Access Compliance Report

(Curb Ramps)

Intersection ID: 21456	Main Street: REGENT RIDGE LN	Cross Street: WITHERS MILL DR	Location: S
ADA ID: 61C23583F0B6	Ramp Type: BlendTrans2	Initial Pass/Fail: Fail	Overall Compliance: No
Severity Score: 21.25			
Codes/Mitigation Info/Possible Solution		Field Measurements/Component Compliance

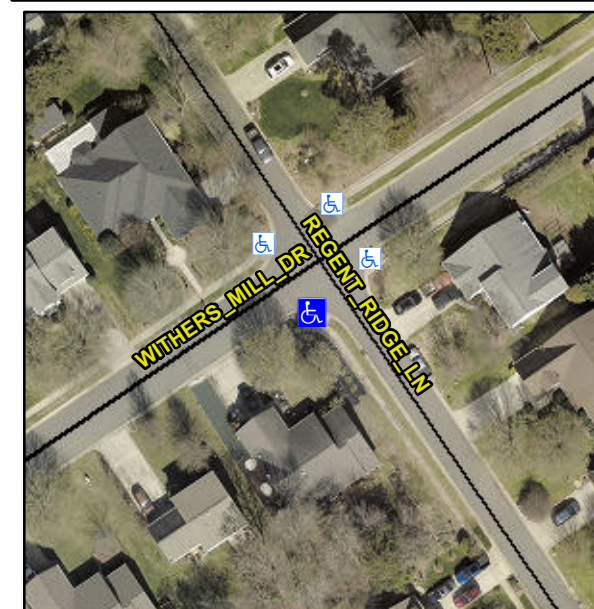
R304.5.1, R304.5.3

Compliance	Description	Data	Compliance	Description	Data
N/A	Ramp Length (in)	94.0	Yes	BlendTrans Slope (%)	2.7
No	Ramp Width (in)	36.0	No	BlendTrans XSlope (%)	6.1
N/A	Flare Type LT	N/A	N/A	Flare Type RT	N/A
N/A	Flare Slope LT (%)	N/A	N/A	Flare Slope RT (%)	N/A
N/A	Flare Traversable LT?	N/A	N/A	Flare Traversable RT?	N/A
N/A	Landing Length (in)	N/A	N/A	DWS Provided?	N/A
N/A	Landing Width (in)	N/A	N/A	DWS Contrast?	N/A
N/A	Landing Slope (%)	N/A	N/A	DWS Length (in)	N/A
N/A	Landing X Slope (%)	N/A	N/A	DWS Full Width?	N/A
N/A	Landing Curb? (Y/N)	N/A	N/A	DWS Offset (in)	N/A
N/A	Shared Landing?	N/A			
N/A	Gutter Ponding?	N/A	N/A	Gutter Slope (%)	N/A
N/A	Gutter Lip Ht (in)	N/A	N/A	Gutter X Slope (%)	N/A
N/A	Painted X Walk1?	No	N/A	Painted X Walk2?	No
	X Walk 1 Direction	To NE		X Walk 2 Direction	To NW
	X Walk 1 Width (in)	N/A		X Walk 2 Width (in)	N/A
	X Walk 1 Slope (%)	0.7		X Walk 2 Slope (%)	6.6
	X Walk 1 X Slope (%)	5.7		X Walk 2 X Slope (%)	0.3

Remove & Replace Curb Ramp With Two New Directional Ramps or Equivalent.
